**ATTACHMENT (3)**

**UNIT 1**

**MARKED-UP TECHNICAL SPECIFICATION**

**MARKED-UP TECHNICAL SPECIFICATION**

FIGURE 2.1-1(a)

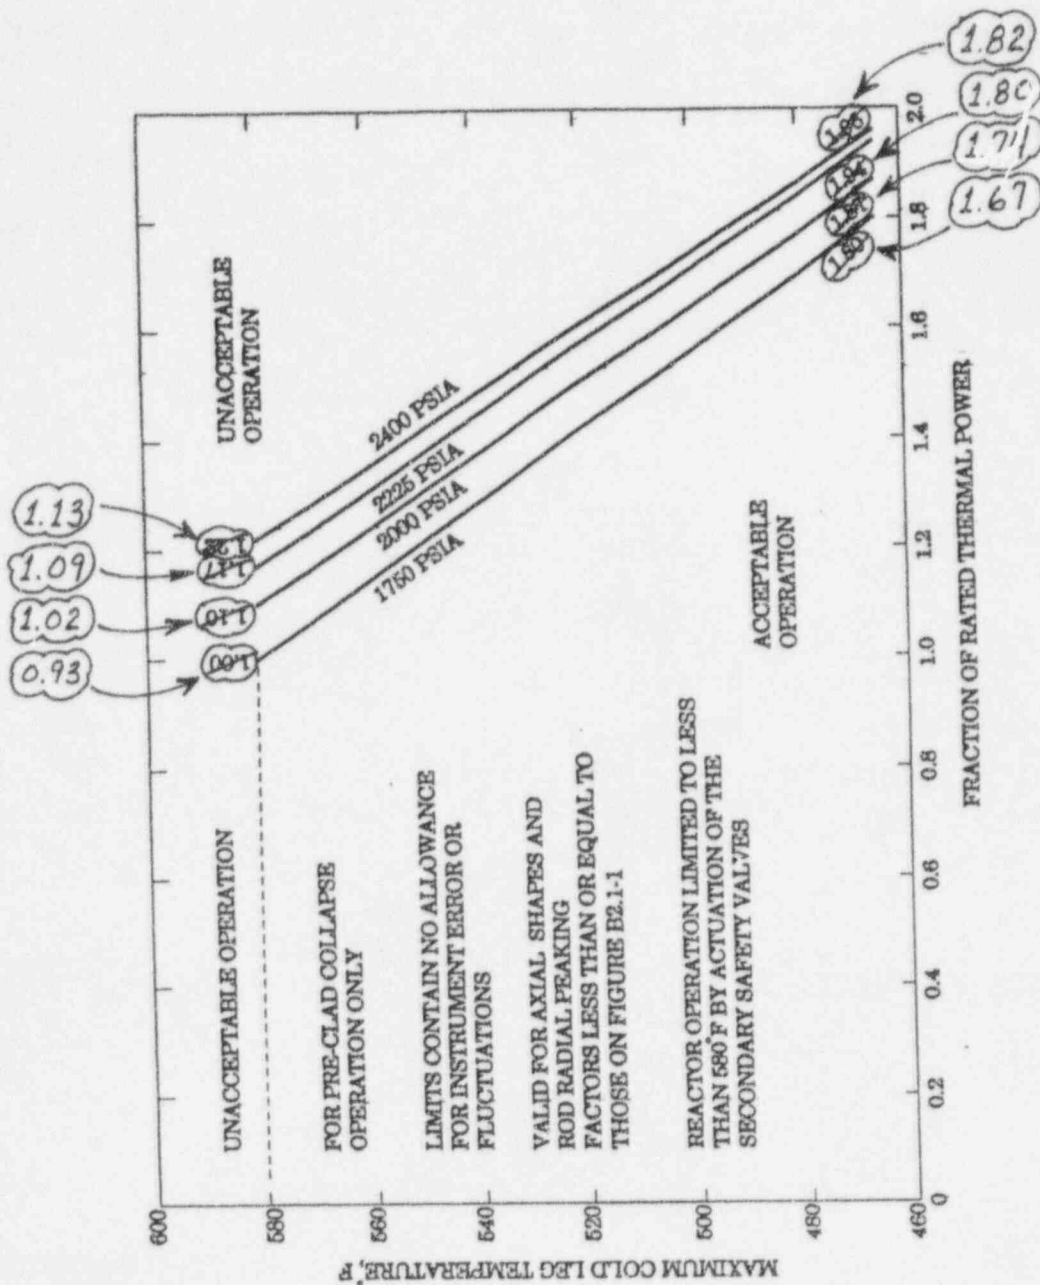
EFFECTIVE THROUGH UNIT 1 CYCLE 13.

FIGURE 2.1-1

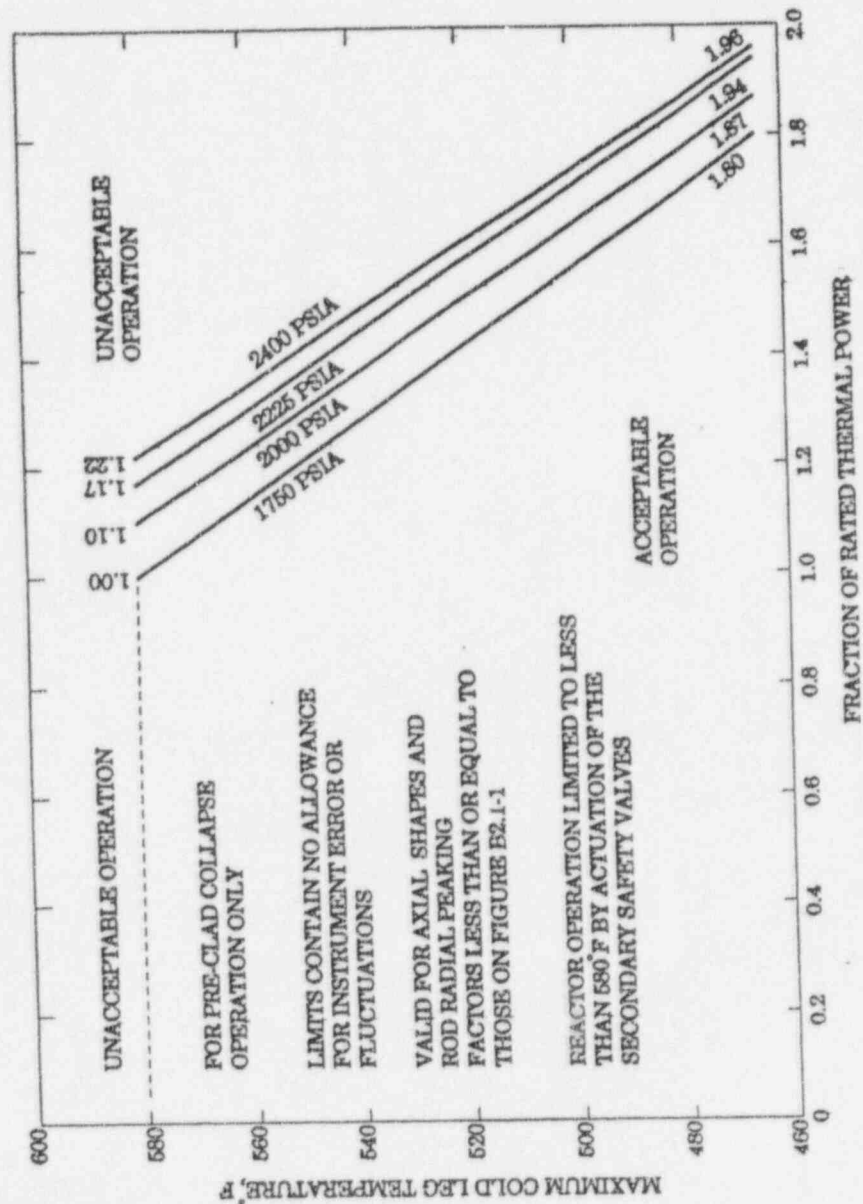
*\* Figure 2.1-1a shall apply through Unit 1 Cycle 13.*

EFFECTIVE AFTER UNIT 1 CYCLE 13.

Figure 2.1.1-1  
Reactor Core Thermal Margin Safety Limit

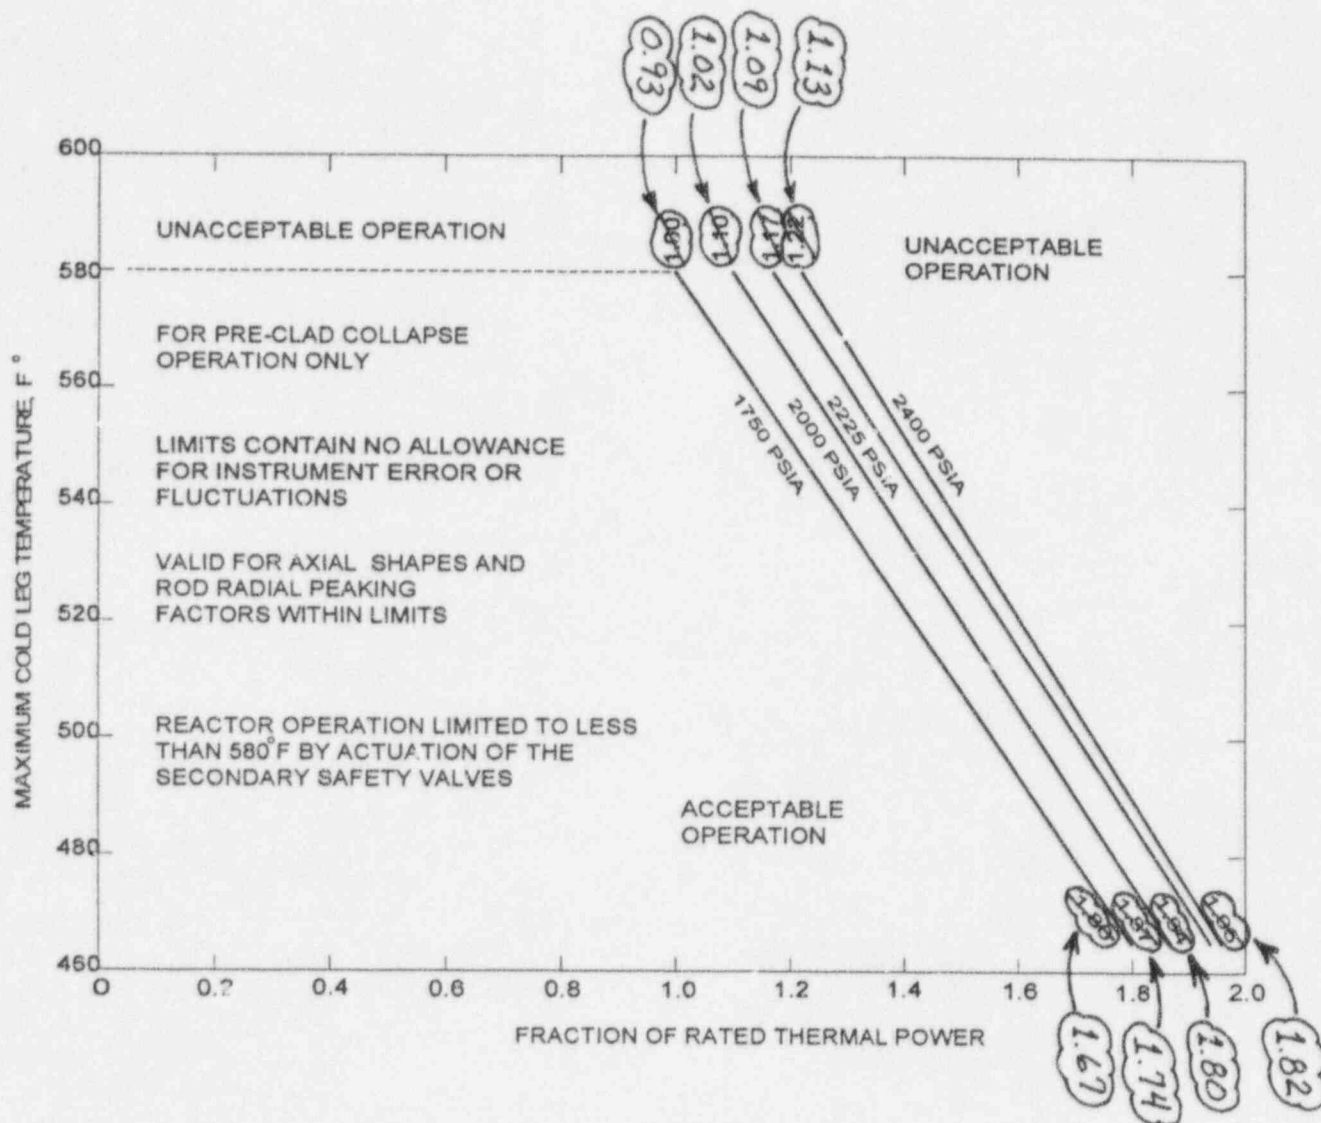
*For Unit 1 only, Figure 2.1.1-1a shall apply through Cycle 13.*

Figure 2.1.1-1-a  
Reactor Core Thermal Margin Safety Limit

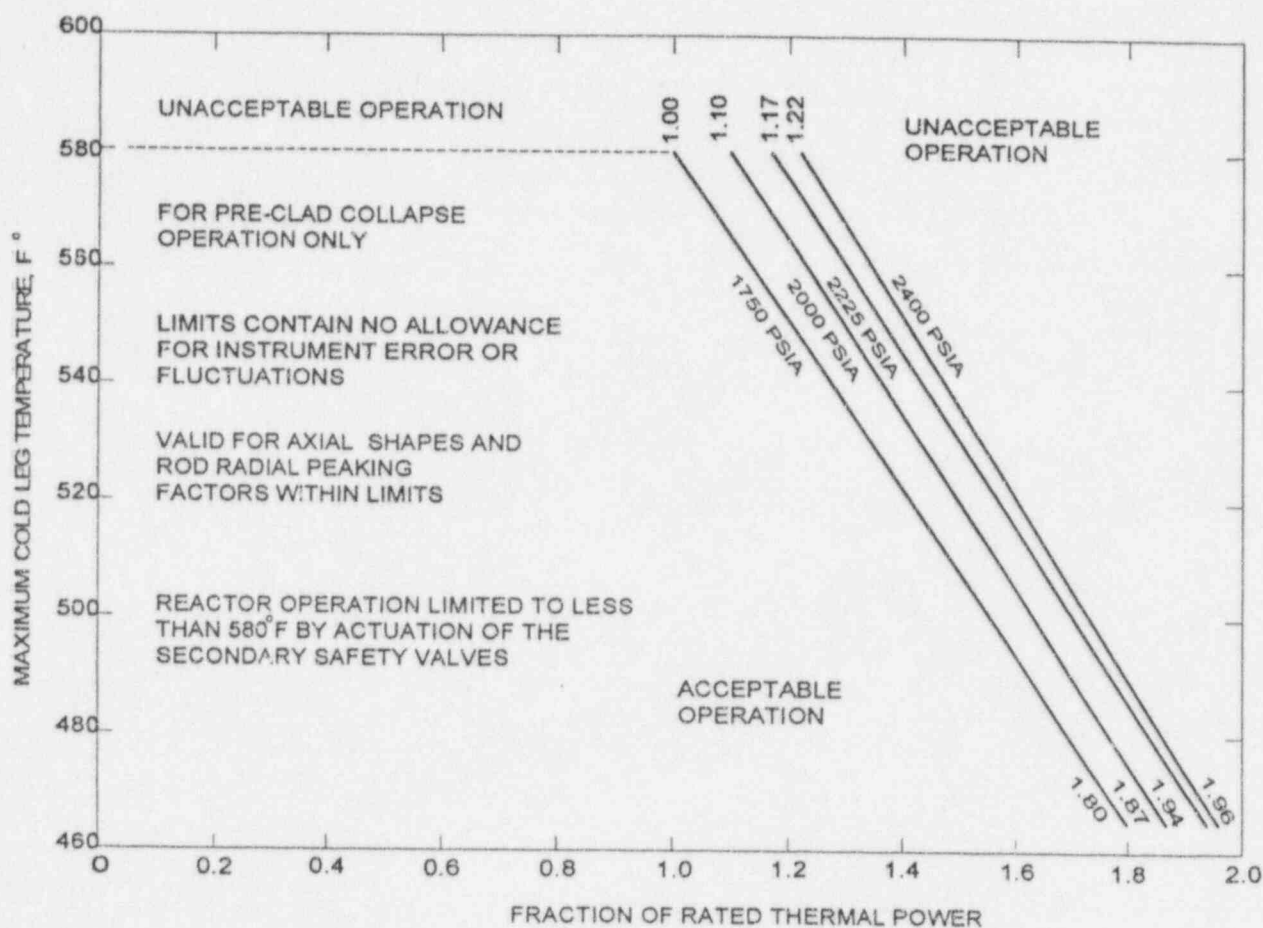
*This Figure only applies to Unit 1 through Cycle 13.*
